FINAL DRAINAGE REPORT
FOR
FALCON DISTRICT 49 TRANSPORTATION FACILITY,
FALCON, CO

Engineer: JVA, Inc.
1319 Spruce Street
Boulder, CO 80301
Attn. Cooper W. Karsh
(303)565-4961

May 23, 2022
Revised September 20, 2022

Figure 6-5. Colorado Springs Rainfall Intensity Duration Frequency

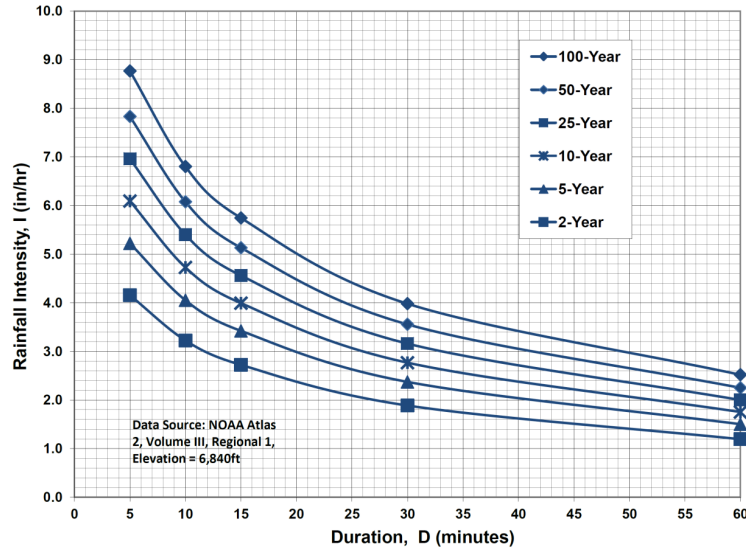
Unresolved Review 1 Comment:
- Use the IDF values from the City DCM, May 2014.
- Remove page

DETENTION BASIN OUTLET STRUCTURE DESIGN

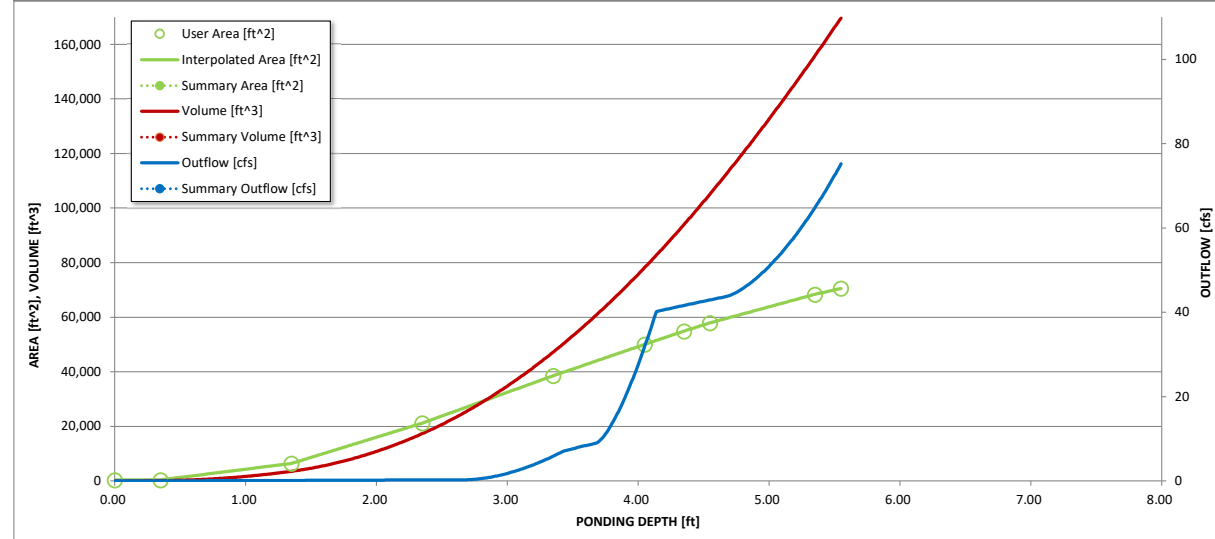
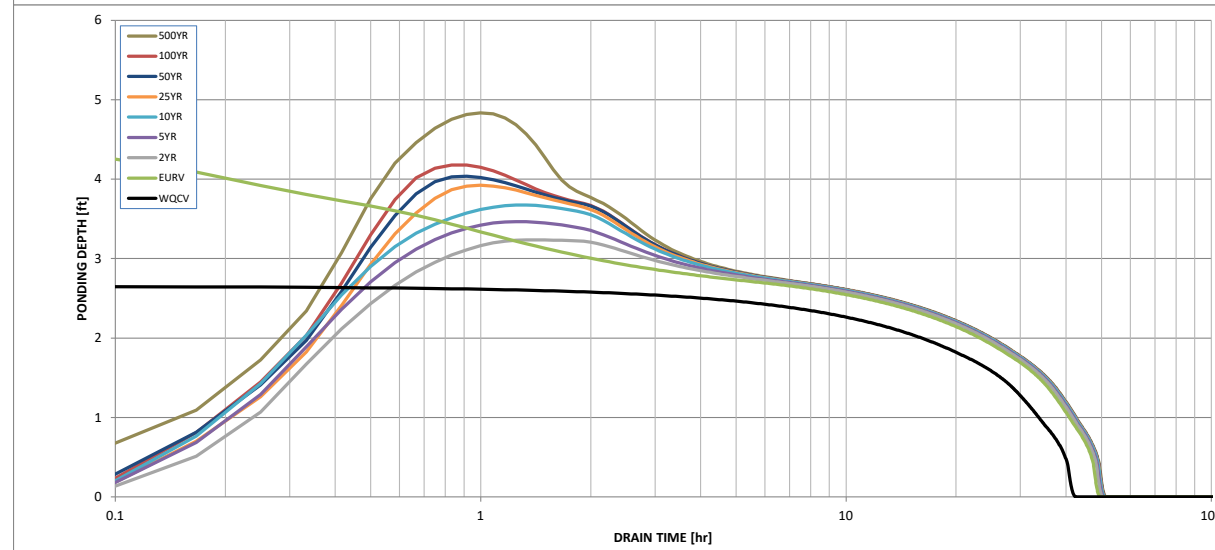
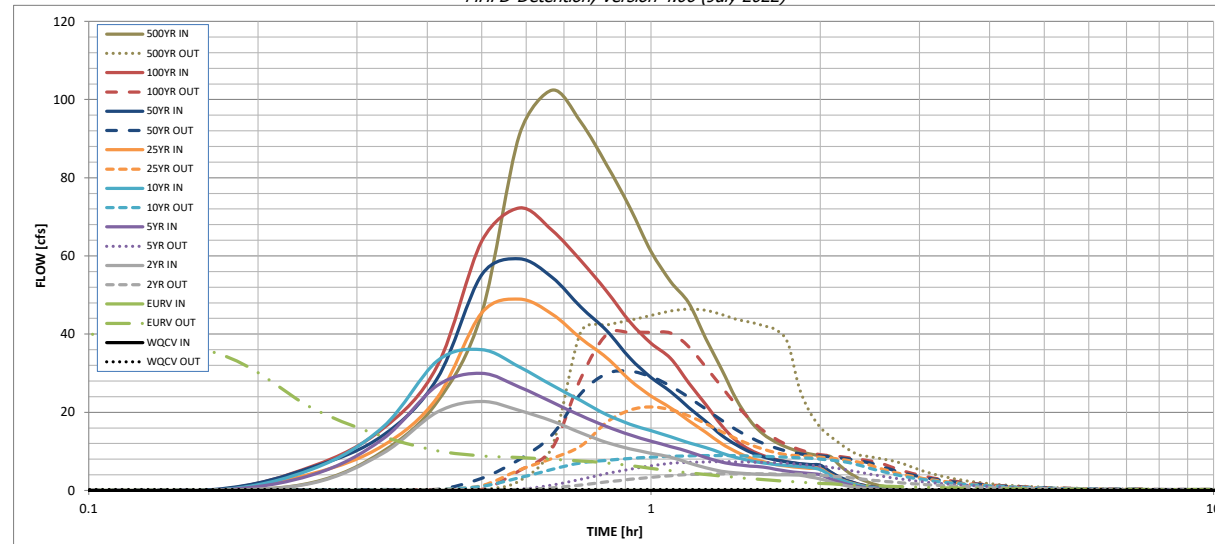
Revise design. For Full Spectrum Design pond release must be equal to or less than historic for all design storm. Ratio must be 1.0 or less.

J:\3456c\Drawings\Exhibits\Figure\3456c-Existing Drainage Map.dwg, 9/20/2022 - 2:34 PM, AMB

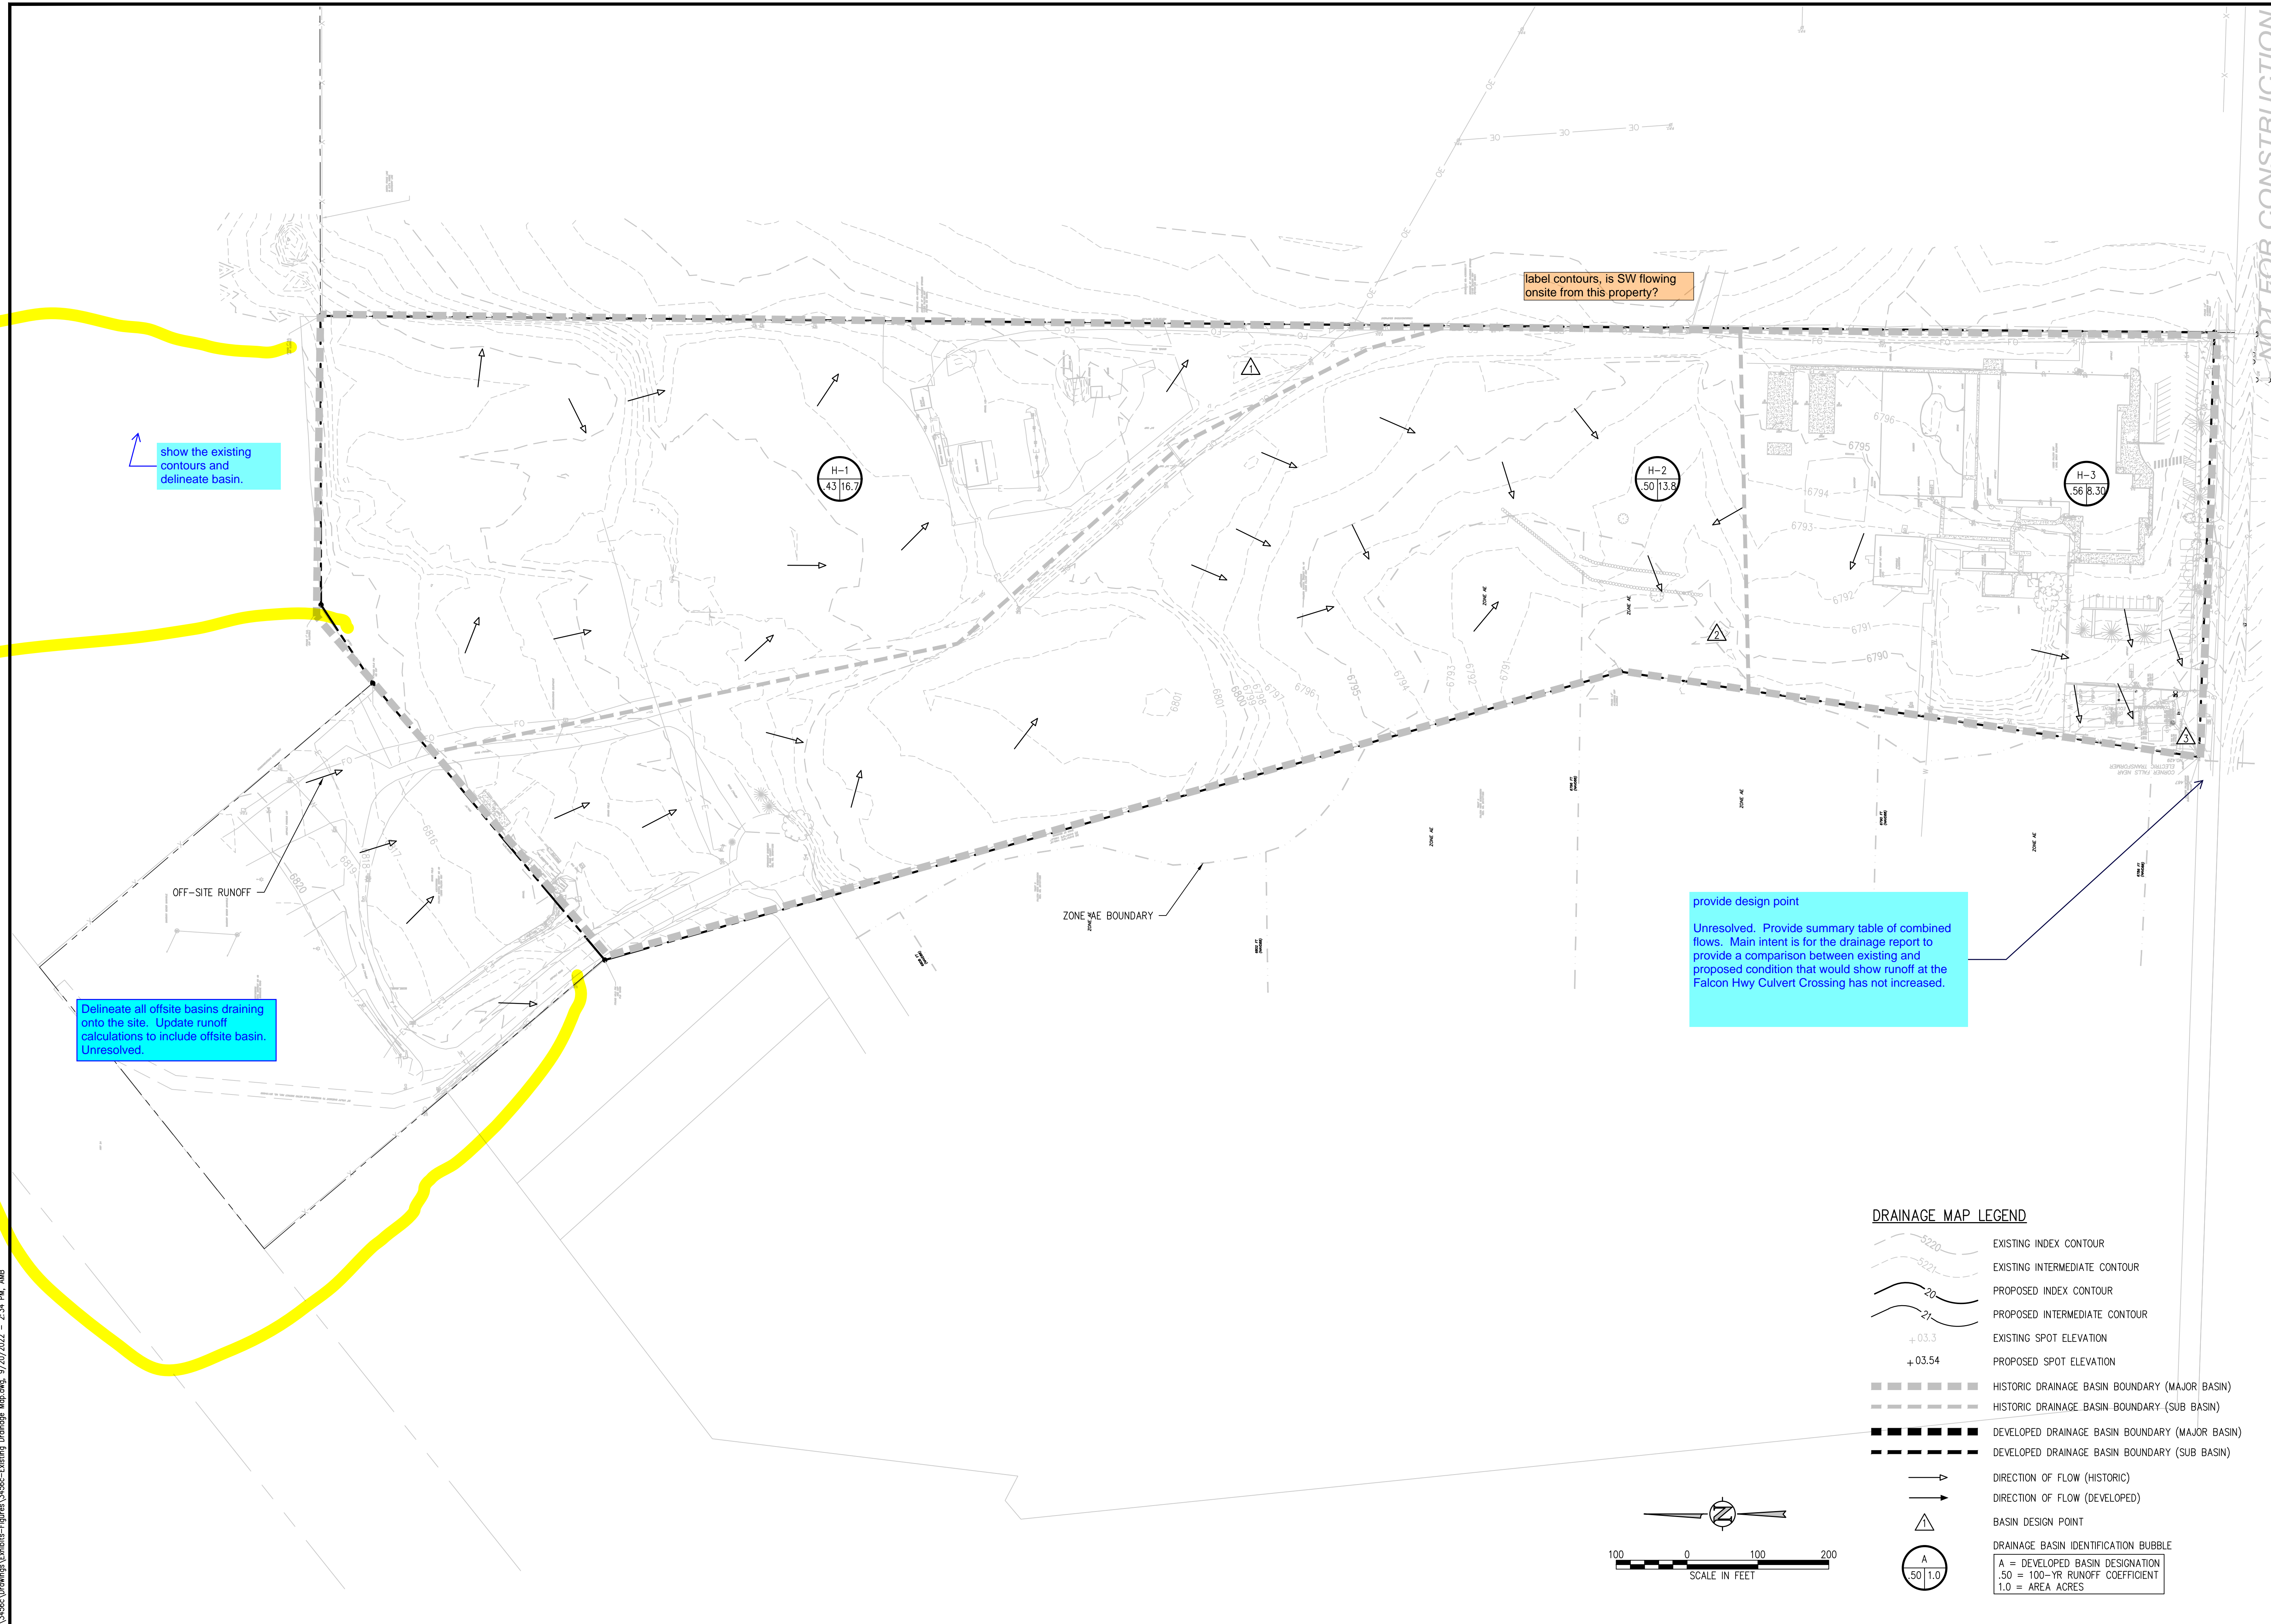
show the existing contours and delineate basin.

label contours, is SW flowing onsite from this property?

Delineate all offsite basins draining onto the site. Update runoff calculations to include offsite basin. Unresolved.

provide design point
Unresolved. Provide summary table of combined flows. Main intent is for the drainage report to provide a comparison between existing and proposed condition that would show runoff at the Falcon Hwy Culvert Crossing has not increased.

It appears offsite flows is being diverted off site at this location. If this is correct then downstream analysis is needed to verify downstream properties are not negatively impacted. Explain in the sub-basin narrative. Add a design point
 Unresolved. Provide the offsite basin analysis. Flow being diverted is unknown.

provide calculations for this culvert and outlet and include text that explains this situation in the DR text. Unclear if the water is supposed to pass over the riprap outfall for the pond and flow into the swale. unresolved.

Provide the sizing calculation for each of the forebays. Recommend using UD-BMP

provide swale hydraulic calculation
 show the existing contours and delineate basin.

provide swale hydraulic calculation

Unresolved. Provide callout to basin A1 noting WQ/Detention required with future development.

Identify and provide construction plans for necessary offsite improvements so the conveyance is hydraulically adequate. Unresolved.

Show the grass buffer area used for WQ.

Provide summary table of combined flows.

Delineate all offsite basins draining onto the site. Update runoff calculations to include offsite basin.

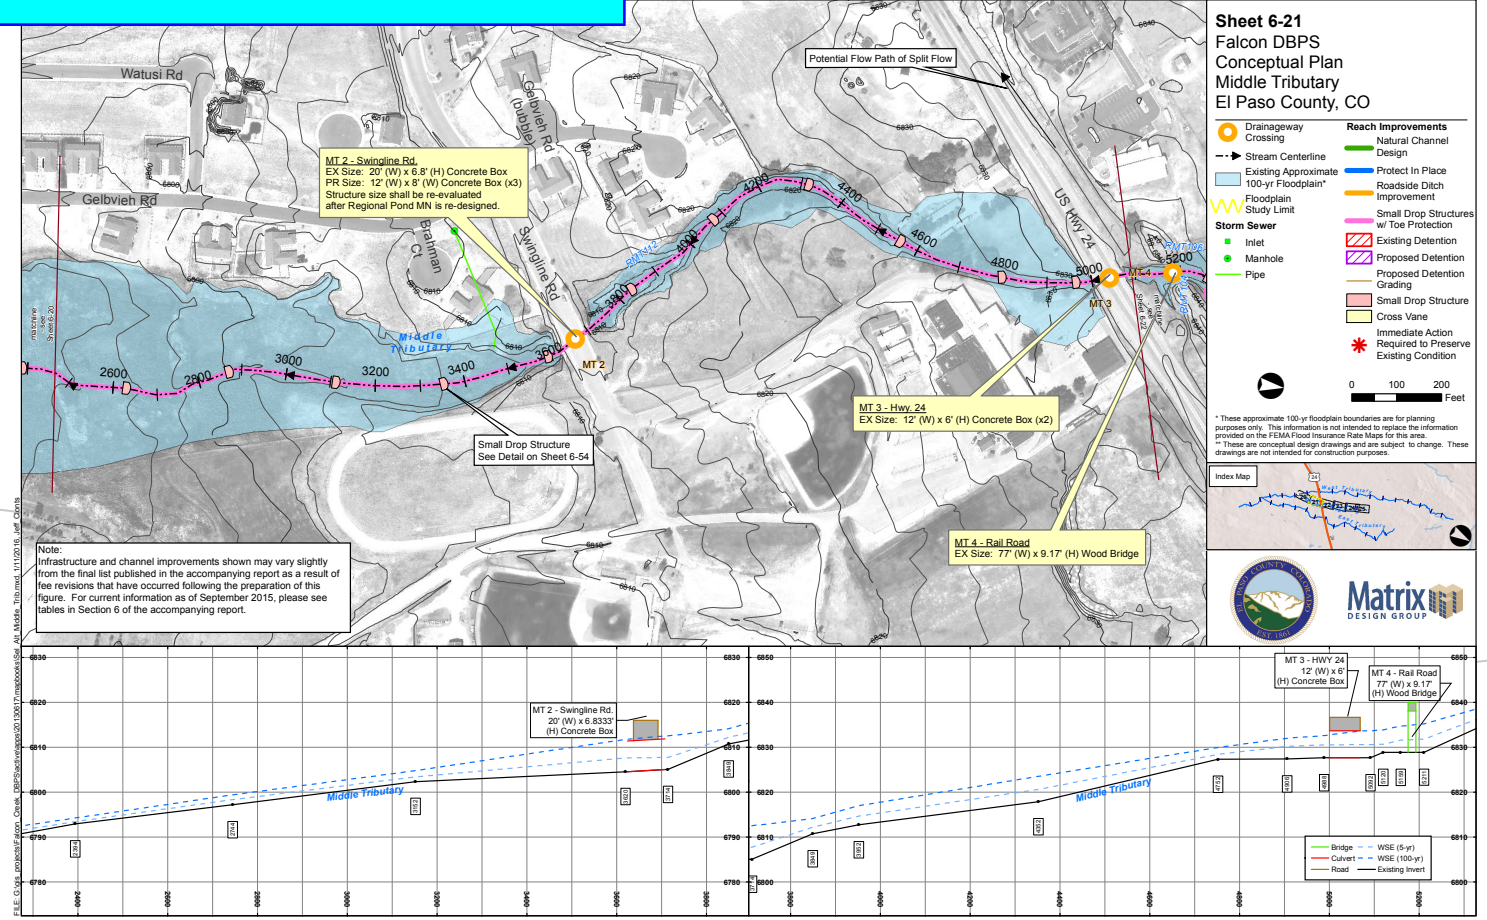
Since the grading and drainage plan is diverting flows then channel analysis (highlighted in blue) must be provided to ensure the receiving channel does not have negative impacts to the channel. Offsite improvements may be required to the receiving channel.

Unresolved.
